MEMORANDUM FOR: A. B. Beach, Director
 Division of Radiation Safety and Safeguards, RIV

SUBJECT: TECHNICAL ASSISTANCE REQUEST; REQUEST FROM CORE LABORATORIES
 FOR AUTHORIZATION TO BURY RADIOACTIVE SOIL PURSUANT TO SECTION
 20.302, 10 CFR PART 20

SUBJECT: CORE LABORATORIES' SEPTEMBER 15, 1989, REQUEST TO
REGION IV FOR PERMISSION TO DISPOSE OF CONTAMINATED SOIL

UNOCAL
RINCON UNIT 24
August 22, 1989

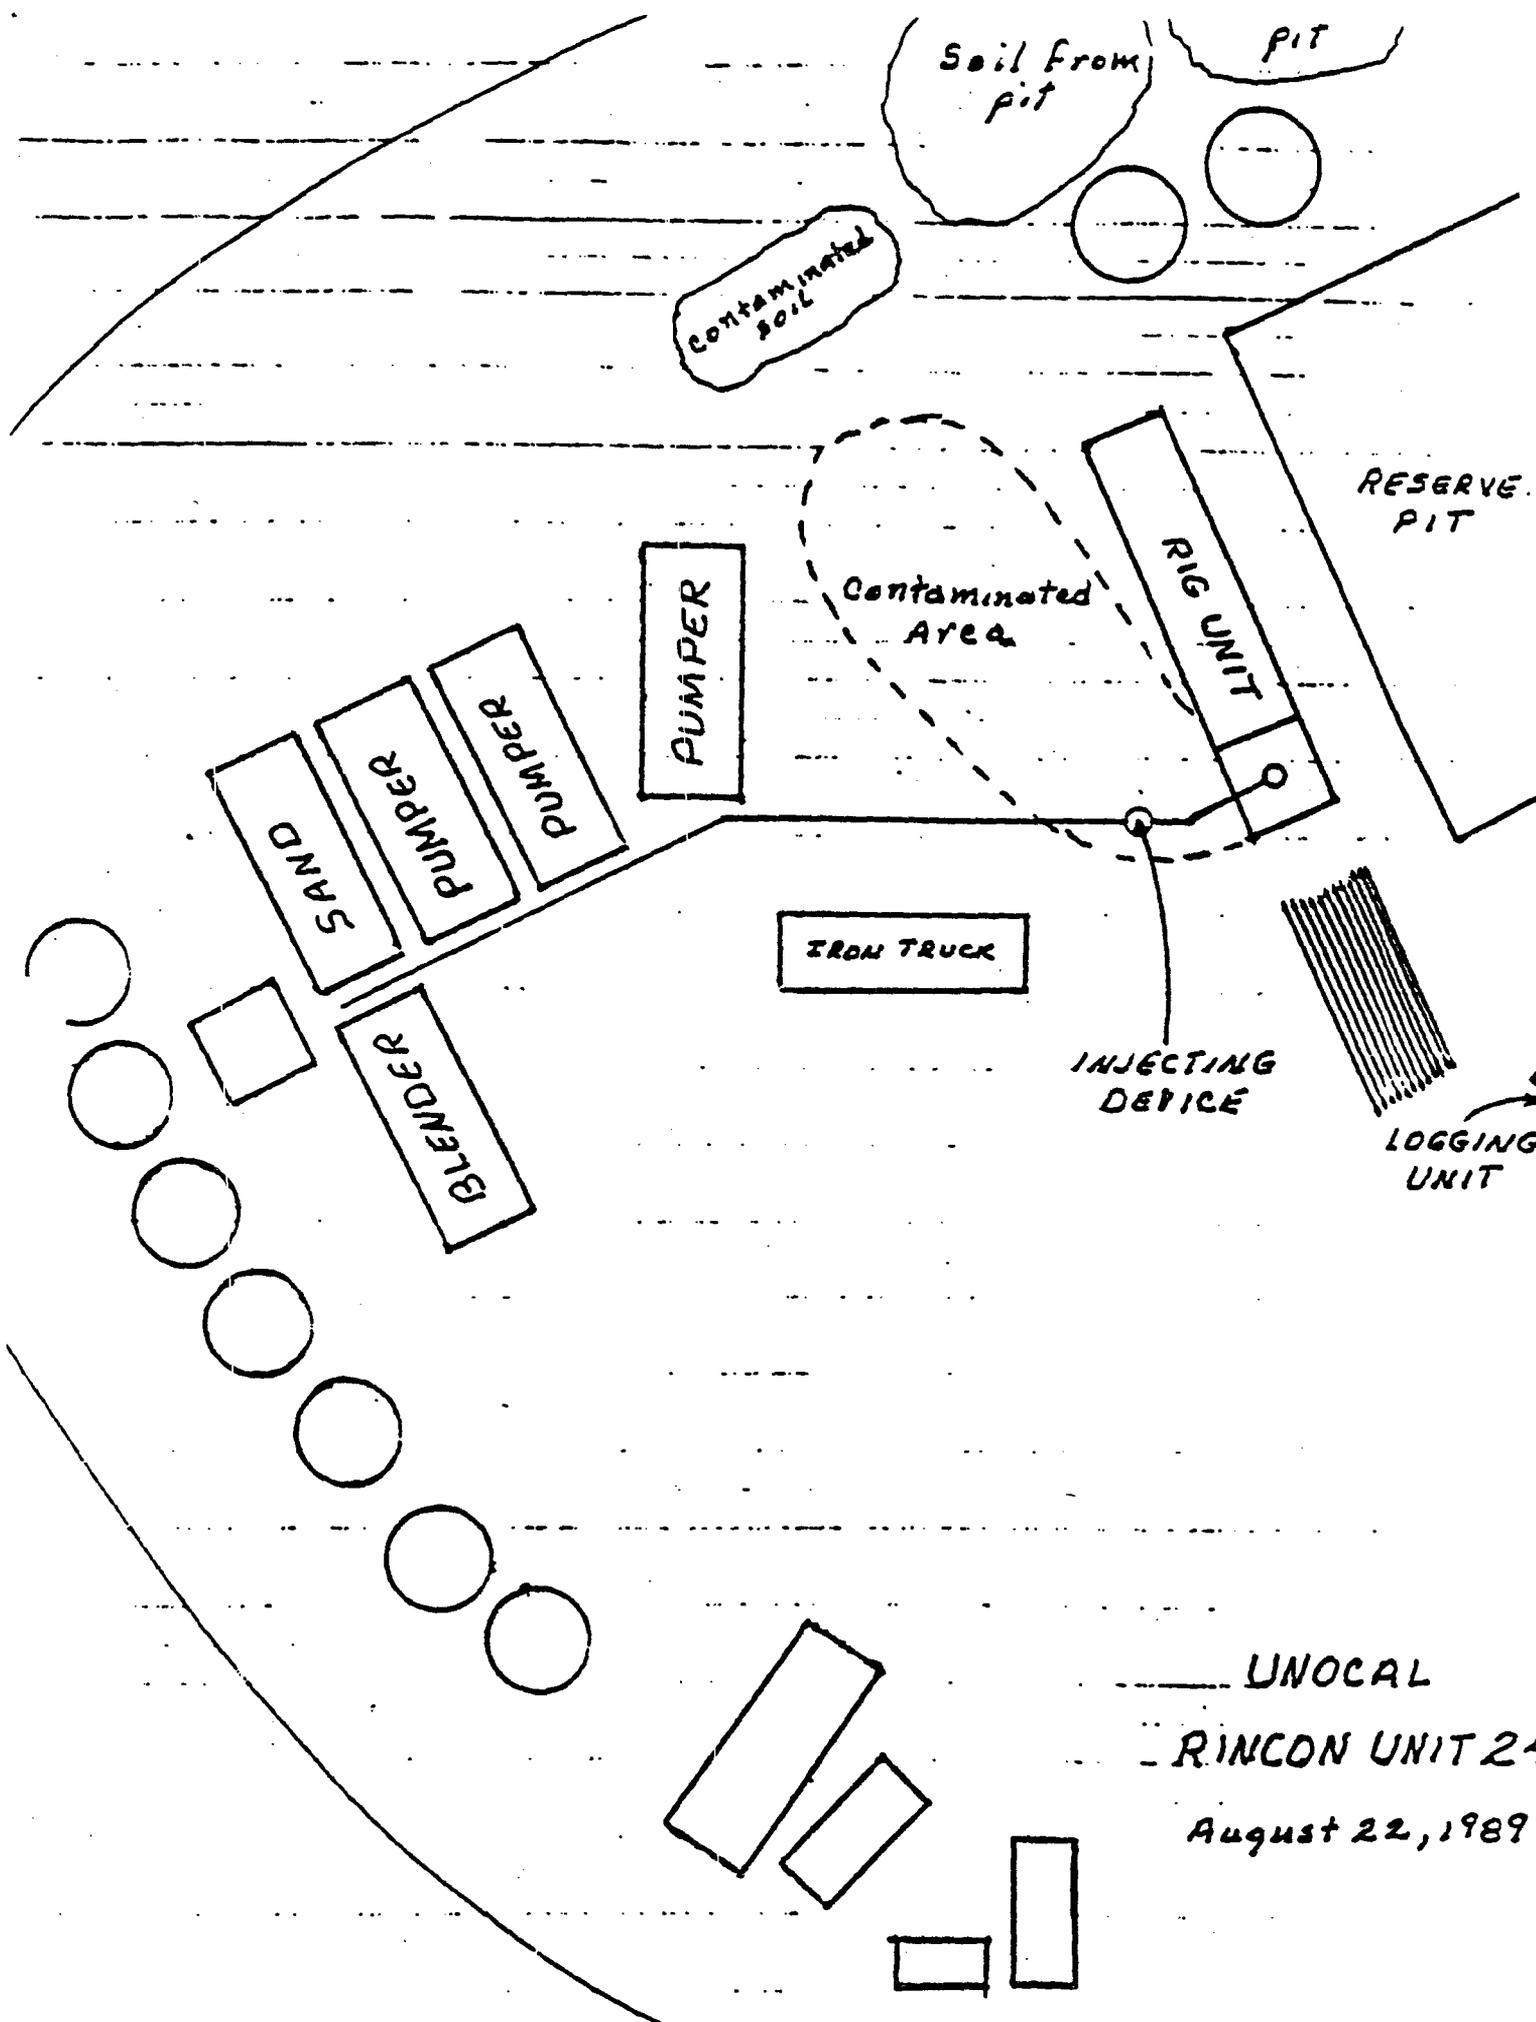
The contaminated fluid flowed out of the top of the "lubricator" onto the outside and down the "lubricator" spilling on the rig floor and ground. Indications were that spray and run-off created the contaminated area, originating at the well (see sketch).
